URBAN DEVELOPMENT INSTITUTE - CALGARY

January 14, 2014

Re: New Community Planning Guidebook

**Agreed Modification - Page 16, 3.1.2 Transit Service
(400m Diagram)**

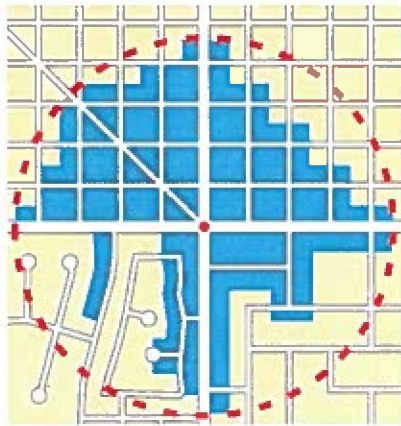
UDI-Calgary requested the diagram on page 16, illustrating the 400m radius five-minute walk from homes to bus stop (section 3.1.2) be modified to model increased connectivity. UDI-Calgary revised the diagram and, we understand, it can be supported by Administration.

Replace the existing diagram on page 16 with the following:

UDI DESIRED POLICY

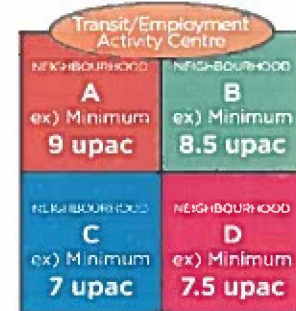
Approve the original recommendation of Administration.

- Flexibility will encourage more creativity, innovation and distinctiveness between neighbourhoods while maintaining a minimum overall community density.

Flexibility for more distinct neighbourhood densities if owners and City can agree at the ASP stage

Still maintain minimum of 8 upac for the whole community.

CPC PROPOSED POLICY

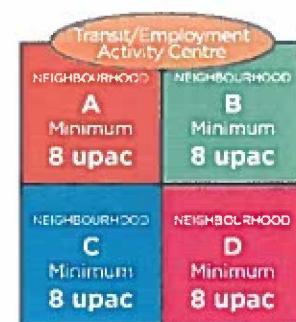
Achieve minimum 8 upac for whole community and for each neighbourhood.

ISSUE 3. – Environmental Open Space

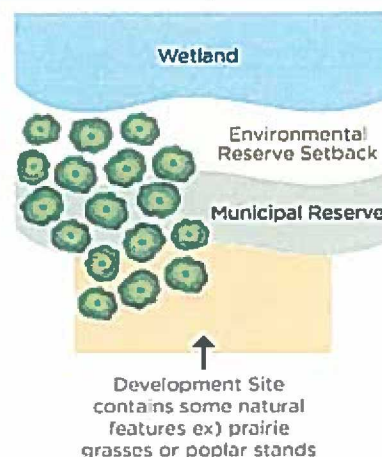
Parks requested the late addition of one clause prior to CPC which was not reviewed by UDI and Administration together. Subsequent to CPC, it was noted by UDI and Administration that this clause is not present in the MDP or in the 3 ASPs (Keystone, Belvedere or South Shepard) and therefore introduces NEW policy.

It is noted that where land in the EOS Study Area is NOT RETAINED but adjacent to RETAINED EOS, it would proceed in keeping with the "Interface" provisions in Section 3.4.2.5.

UDI's preferred solution is to REMOVE the clause on the basis it introduces NEW policy and is redundant.

The second option is to refine it; noting that doing so seems to create redundancy with the 'Interface' provisions that follow it.

(a) Modification - Remove Page 29, Section 3.4.2.4.e

(b) Modification - Page 29, Section 3.4.2.4.e

e. Development in EOS Study Areas that are not protected as above **should be encouraged to** proceed in a manner that is sensitive to, and minimize impacts on **adjacent** ecosystem assets.
